Technical Service Bulletin: TSB180021

Released Date: 08-Mar-2018

Two Stage Fuel Air Bleed Valve

Figure 1, Single Stage Air Bleed Valve, Part Number 4928063

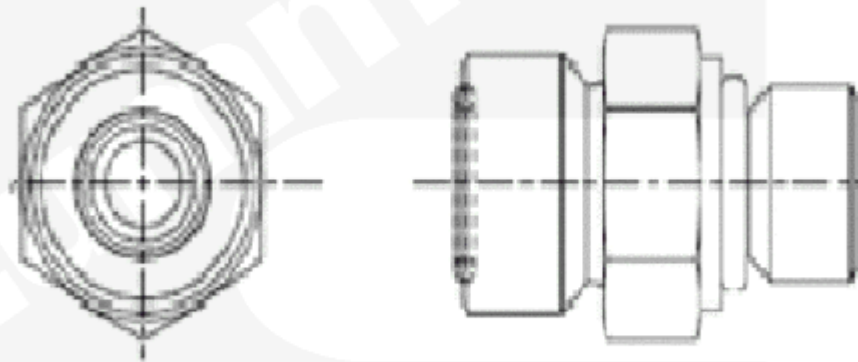
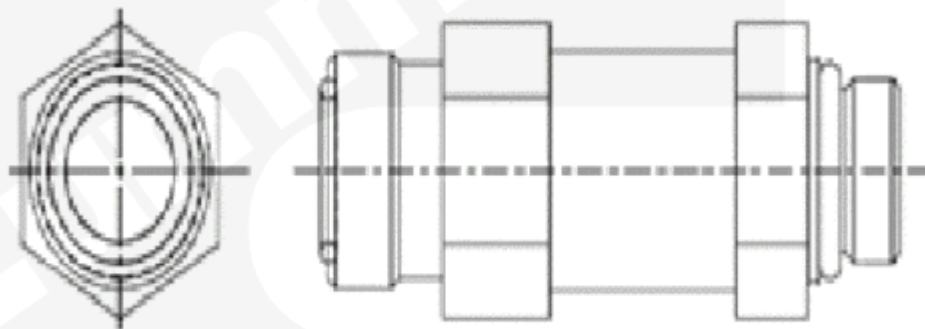
MCRS fuel system changed from a single stage check valve to a 2 stage check valve.

Figure 2, 2 Stage Air Bleed Valve, Part Number 4379736
